February 25, 1992
LD-92-030

Docket No. 52-002

Subject: Response to NRC Requests for Additional Information

RESPONSE TO NRC REQUESTS FOR ADDITIONAL INFORMATION
STRUCTURAL AND GEOSCIENCES BRANCH

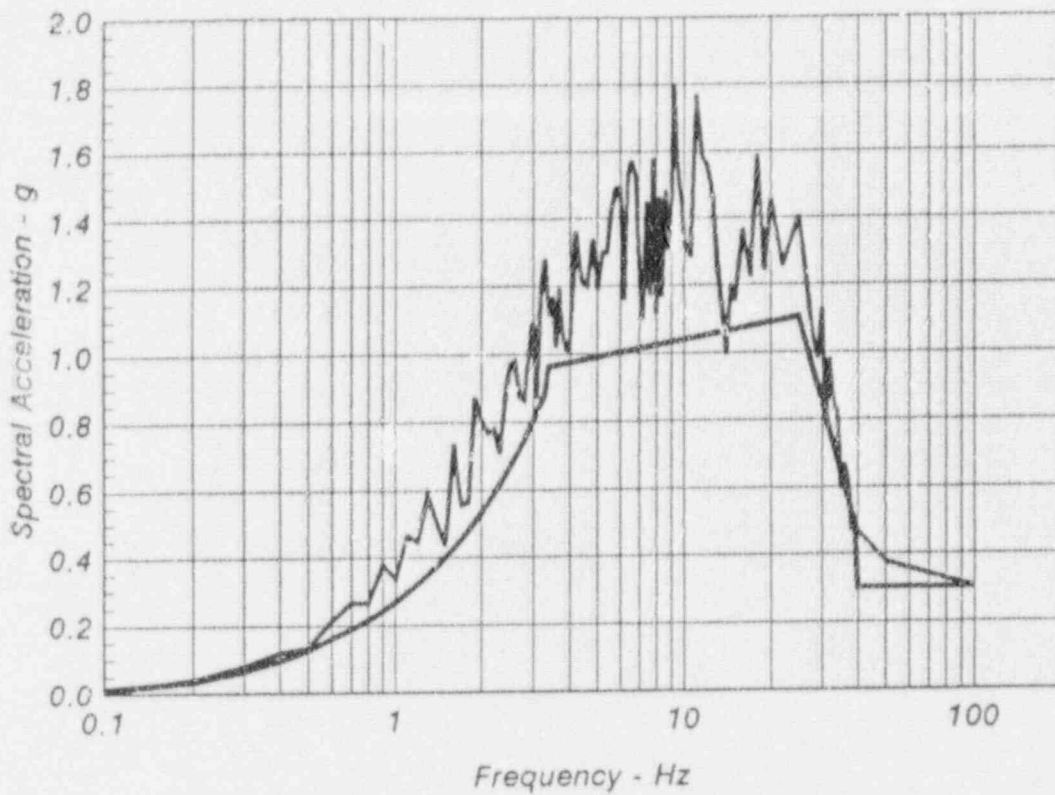
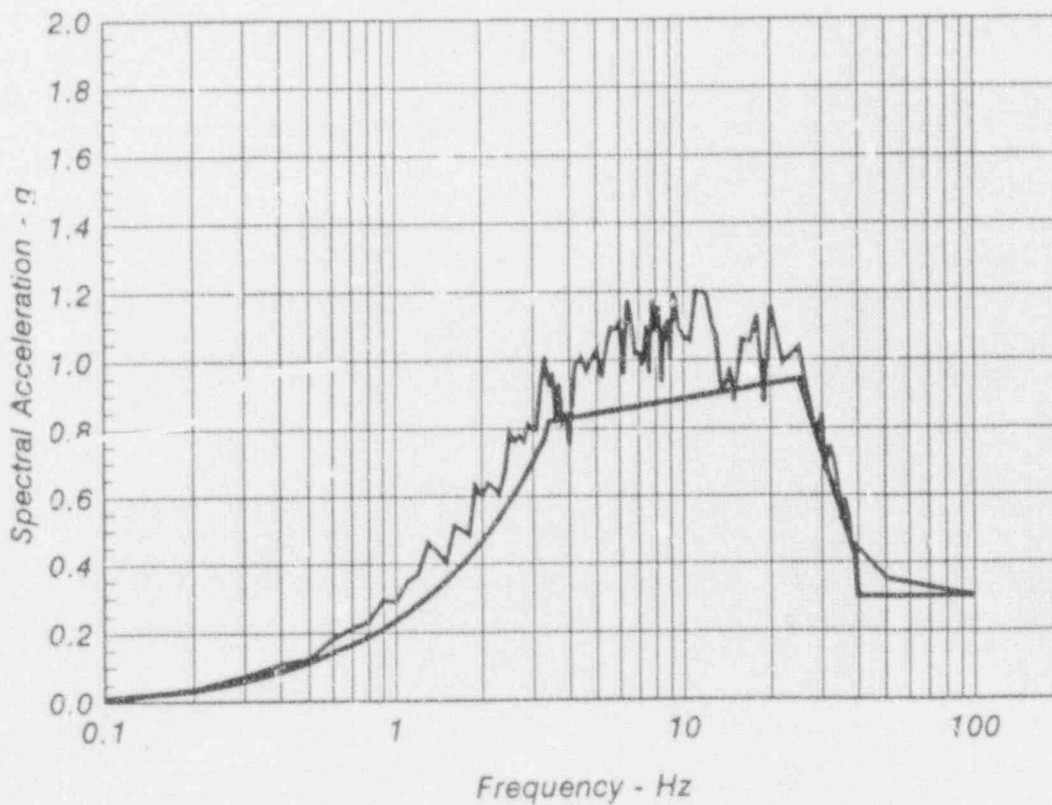
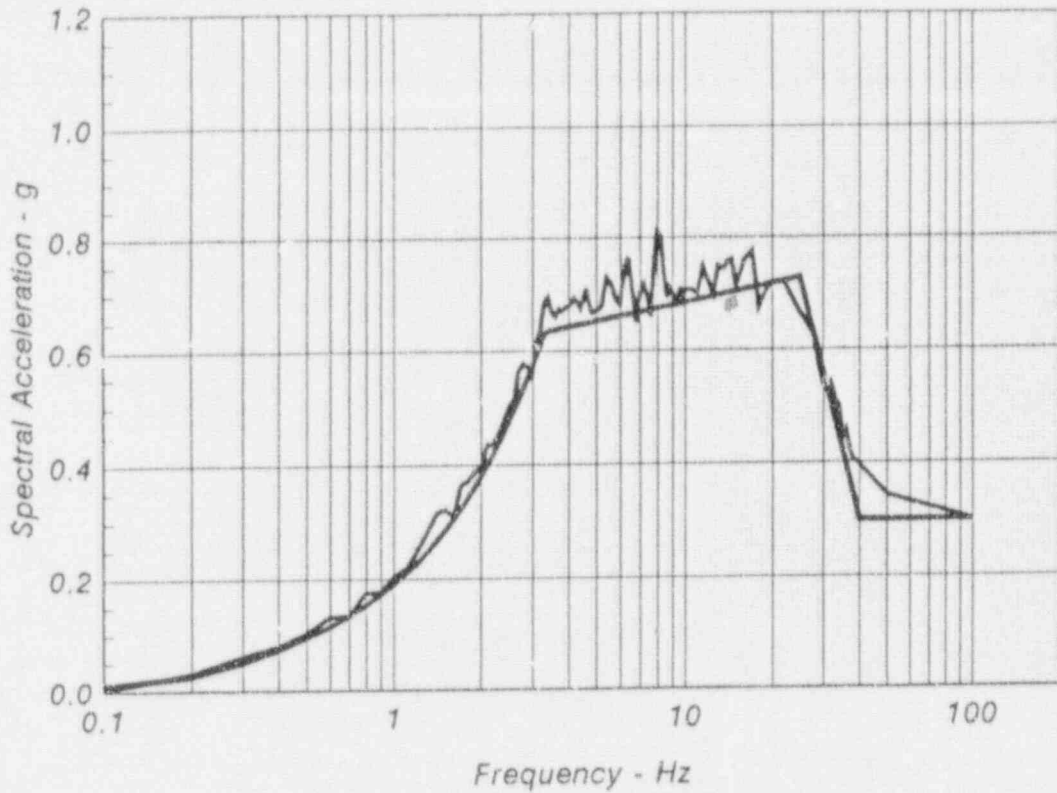
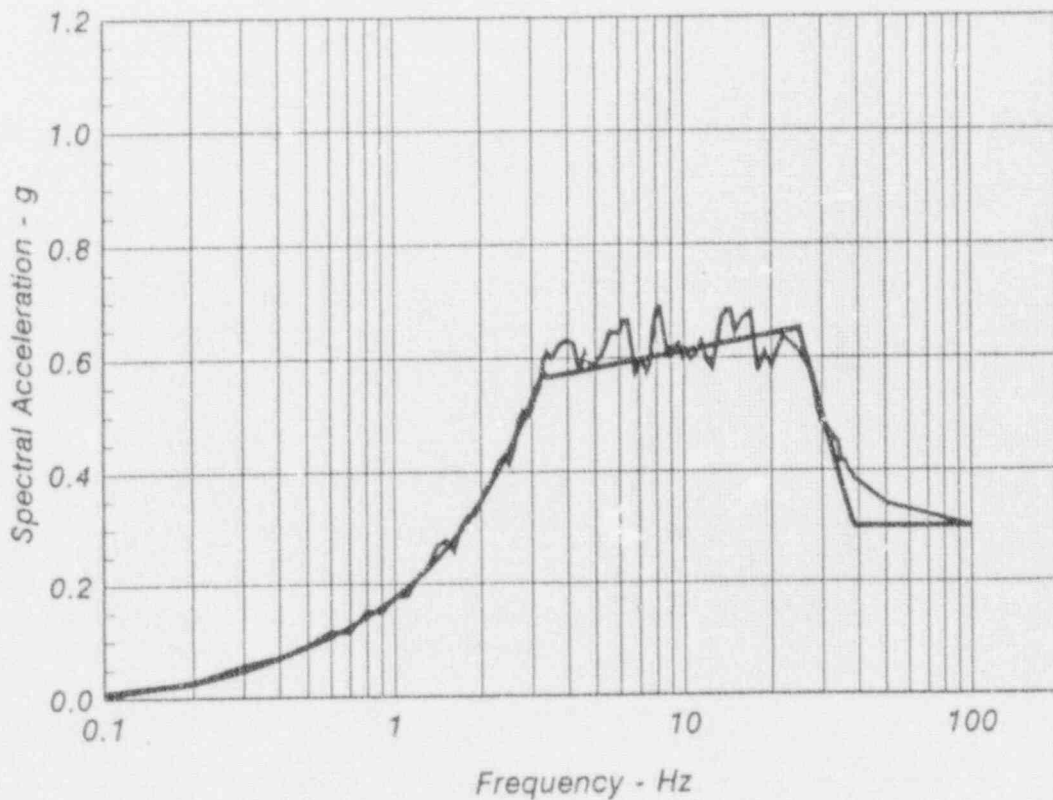
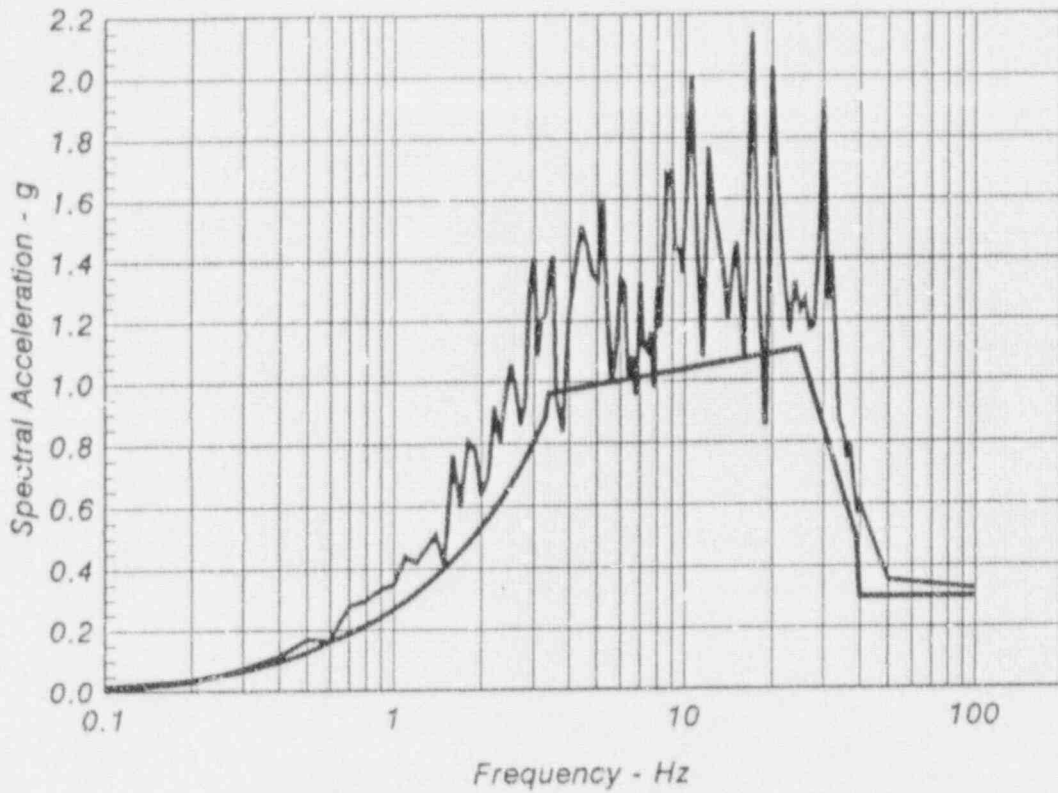
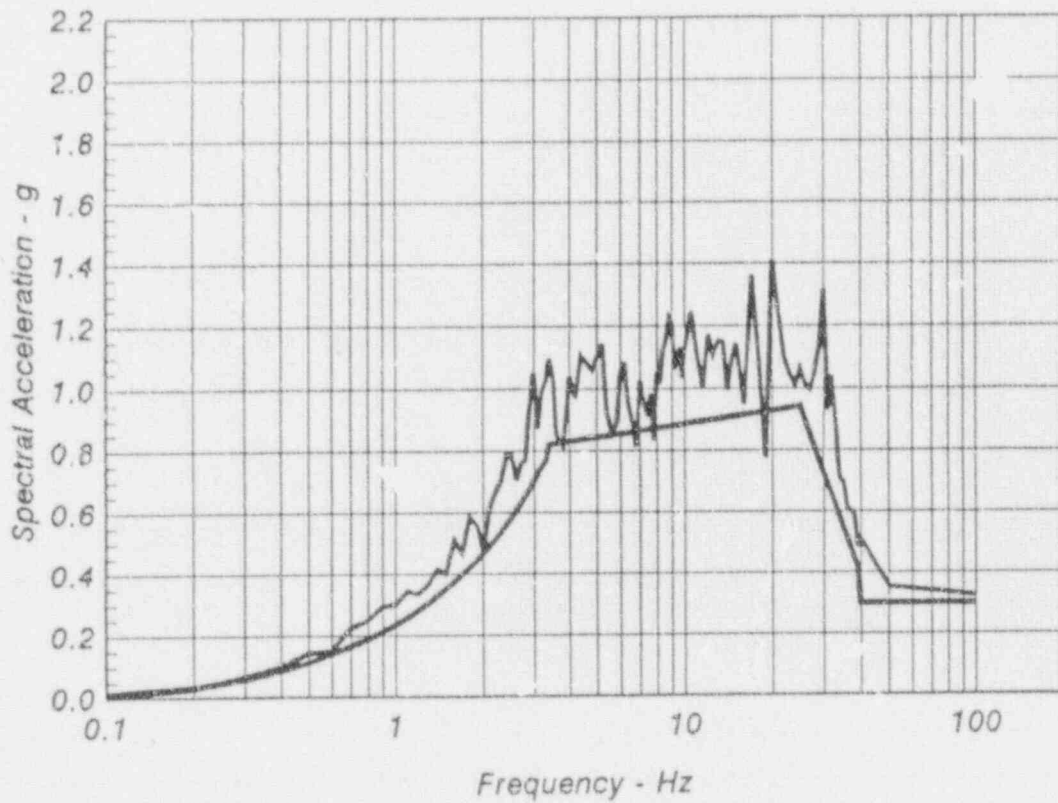
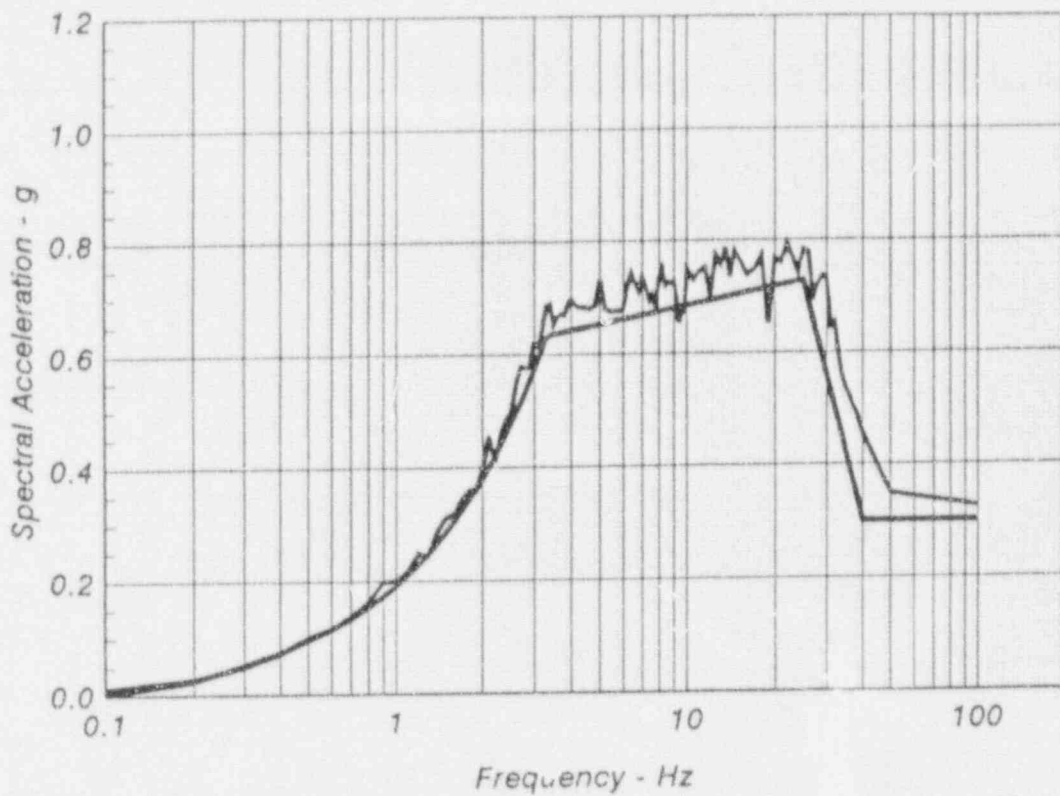
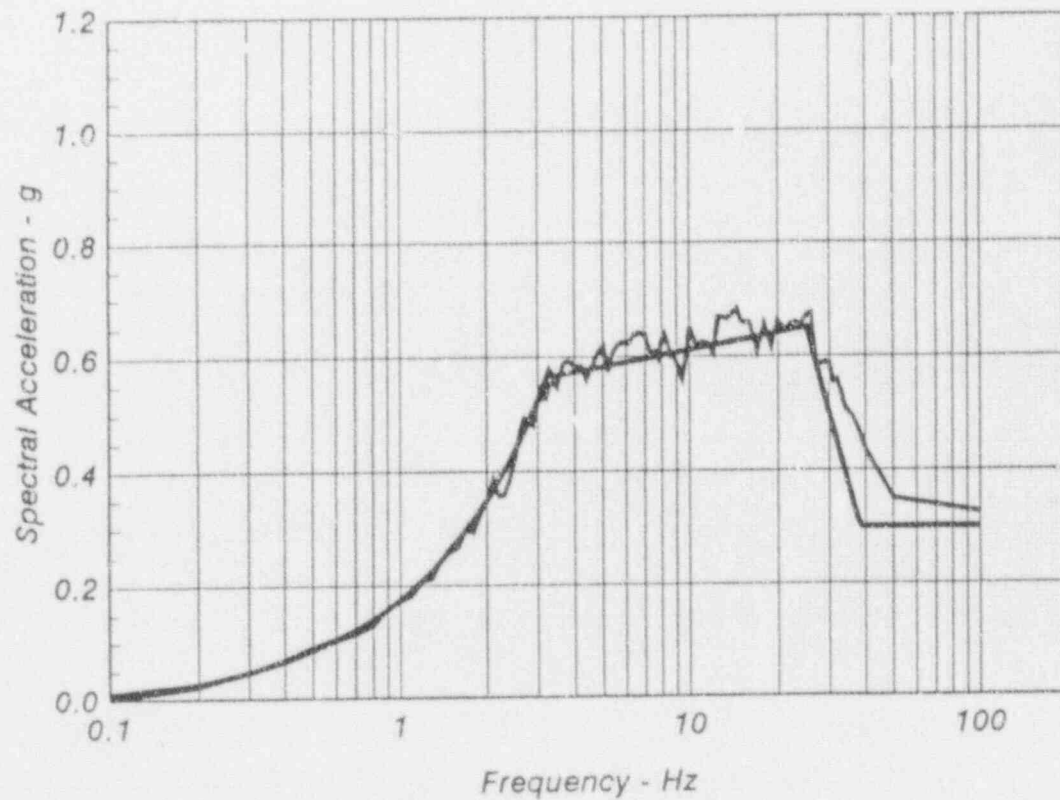
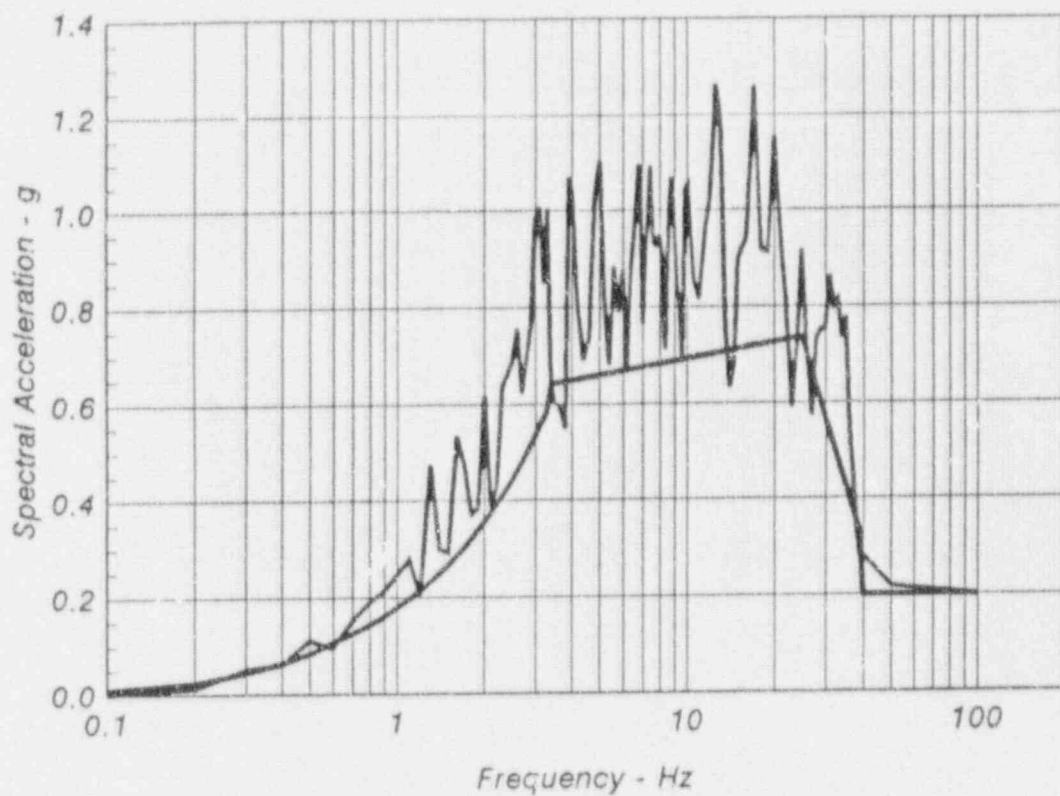
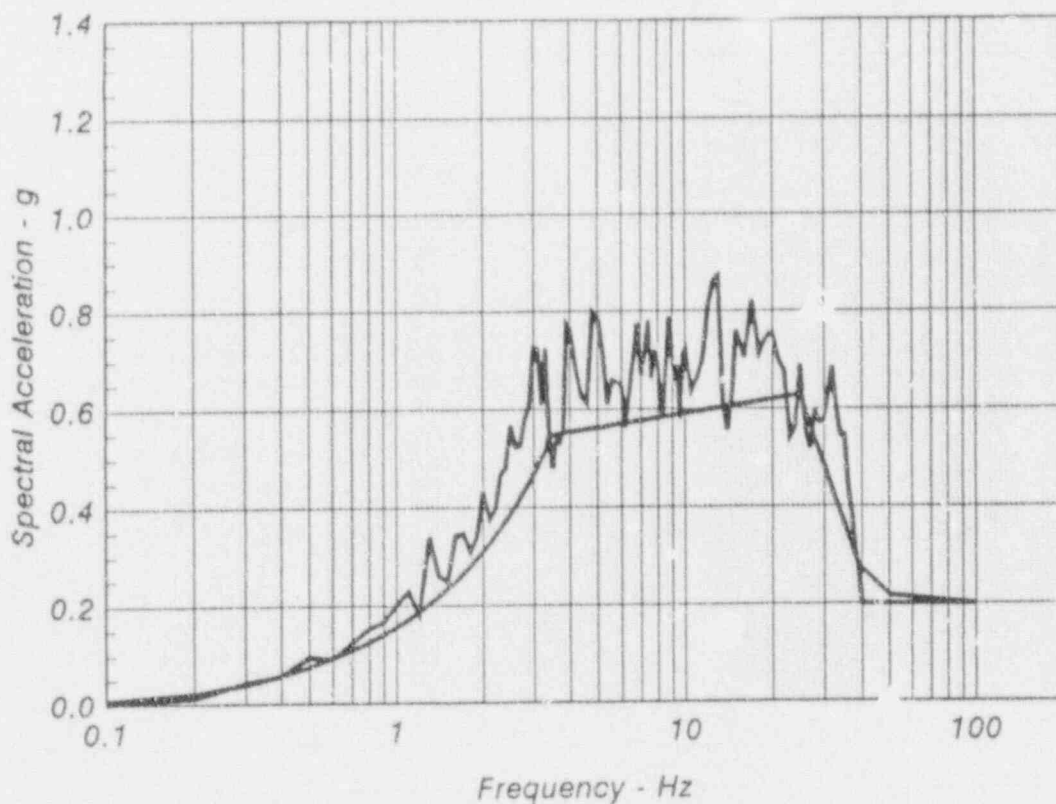
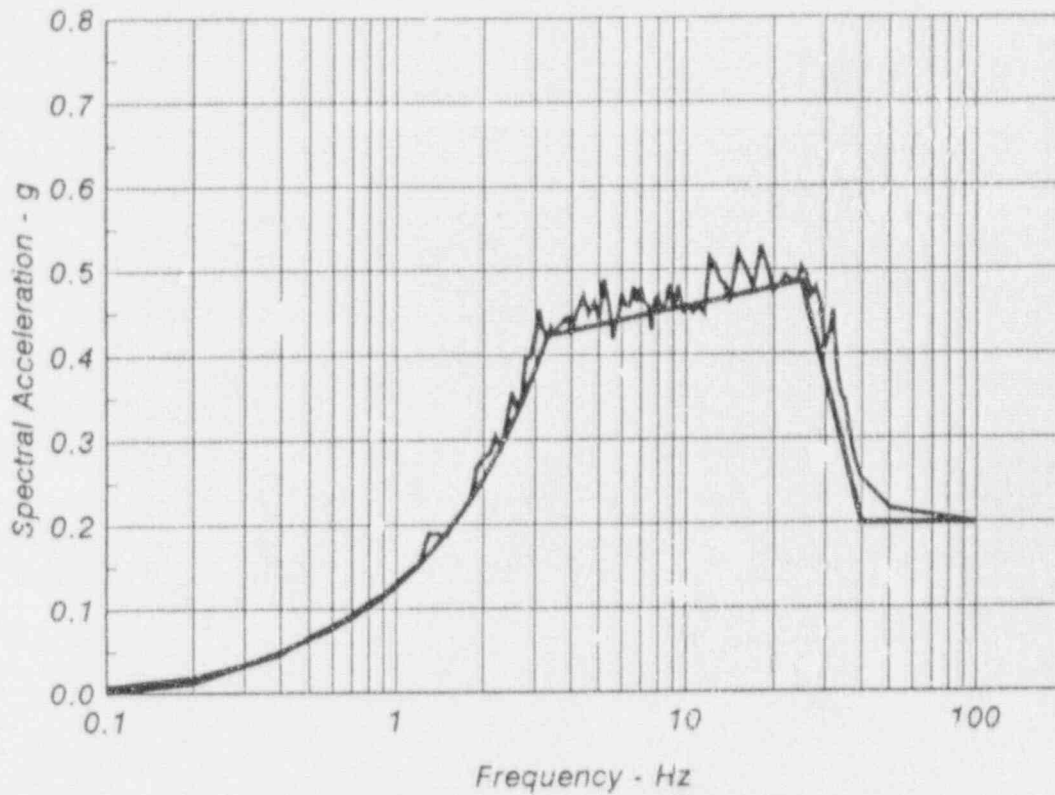
Section 3.7.1.2 - Figures 3.7-25 through 3.7-27 are for damping values of 5 percent. To show the appropriateness of these time histories, provide and discuss similar figures for other damping values that will be used in the design of all Category I structures, systems, and components.

Finally, the spectral ordinates for damping ratios of 1, 2, 5 and 7 percent were calculated for the synthetic time histories, H1, H2 and V and these were compared with the target smooth spectrum for the appropriate damping ratio. These comparisons are provided herein in Figs. 1a through 3d.

Figure 1a shows the comparison for H1 at a damping ratio of 1 percent, Fig. 1b is a similar comparison at a damping ratio of 2 percent, Fig. 1c is for a damping ratio of 5 percent and Fig. 1d is for a damping ratio of 7 percent. Corresponding comparisons are presented in Figs. 2a, 2b, 2c and 2d for H2 and in Figs. 3a, 3b, 3c and 3d for the vertical synthetic time history, V.

The results shown in Figs. 1a through 3d indicate: (i) the spectral ordinates of the synthetic time histories provide a reasonably conservative envelope to the target smooth spectrum at damping ratios from 1 to 7 percent for the frequencies of interest; and (ii) the amount of conservatism increases with decreasing damping.
